MTW / HVO
Lemington Underground Mine
Water Storage Project

Warkworth Mine

SUBMISSIONS REPORT

Figure 1: Plan of of Lemington Underground Mine and surface features in the vicinity.

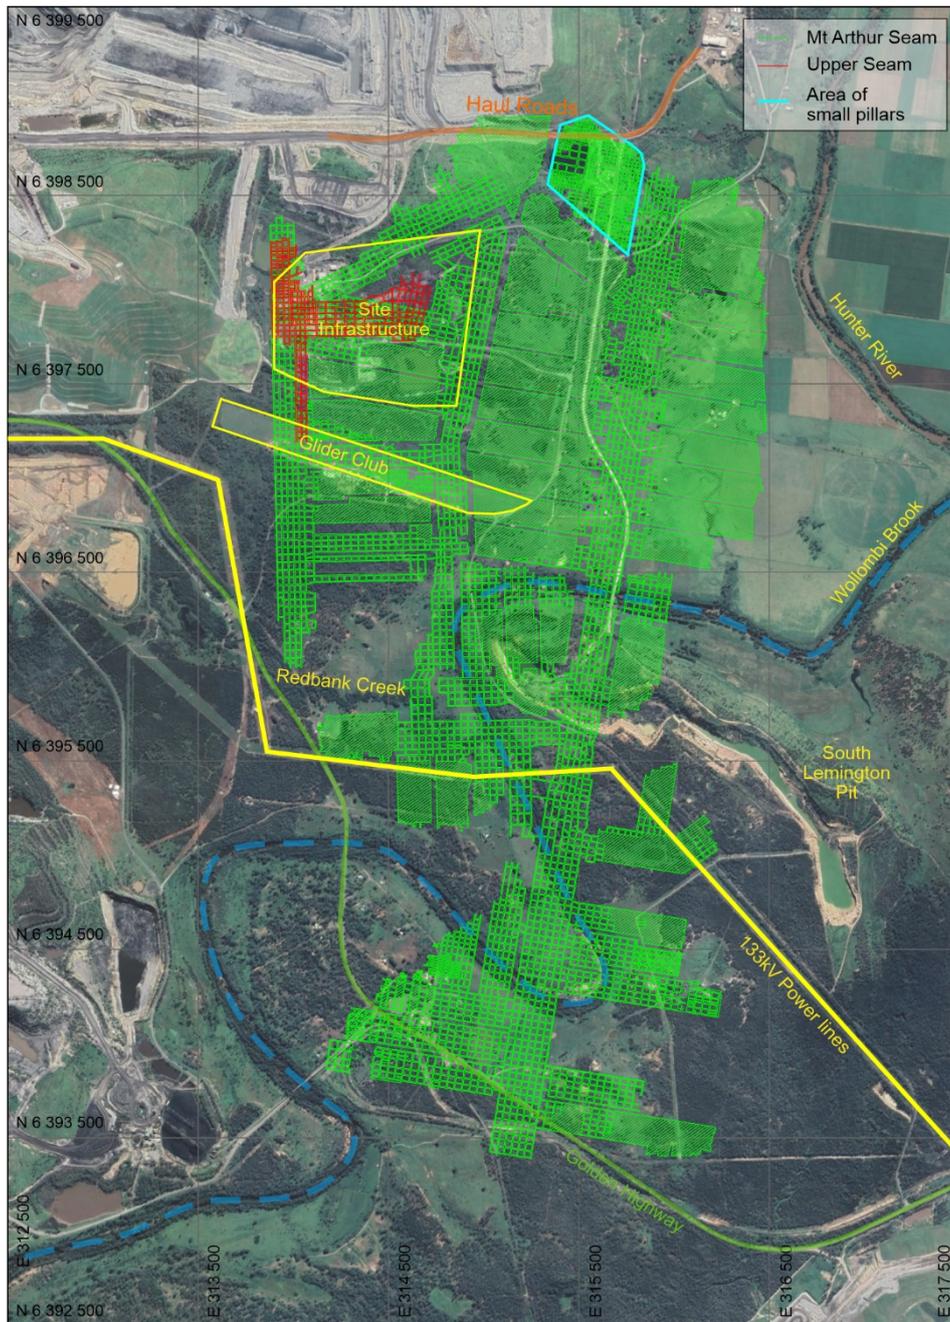
The BCD recommends that Yancoal assess the subsidence risks associated with using the bord and pillar mining void to store water. The BCD states that *“The Lemington Underground Mine extends beneath the Hunter River, Redbank Creek and Wollombi Brook. Surface disturbance of the workings could impact these water courses, including changing the longitudinal stream profile gradient and streambed cracking.”* The BCD also notes that *“Surface disturbance from the subsidence of the old Lemington Underground Mine has the potential to expose the Hunter River, Redbank Creek and Wollombi Brook to an increased frequency of flooding or to flood risks that may not have existed previously.”*

An approximately 20ha area of small split and quartered pillars in the northern part of LUM, shown in Figure 1, is likely to be exposed to wetting and drying if the water level cycles in the underground mine cycles above about RL5m Australian Height Datum. The surface above this area, owned by HVO, would be vulnerable to sudden subsidence if pillar instability occurs. However, as this area is not close to the Hunter River, Wollombi Brook or Redbank Creek, there would be no potential for this subsidence to impact these watercourses.

Rib spalling in this area of small pillars is expected to become sufficient over time to reduce the nominal probability of failure to between 1 in 100 and 1 in 300. This probability of failure is not considered long-term stable and surface subsidence in this area could therefore be expected to develop at some stage. Pillar instability of any one of the numerous small pillars in this panel would be expected to lead to sudden subsidence of up to 1.5-2m across most of the panel. Two haul roads, various minor roads and road intersections, and a dam appear to be the main surface infrastructure currently located above this panel of small pillars. The land is owned by HVO.
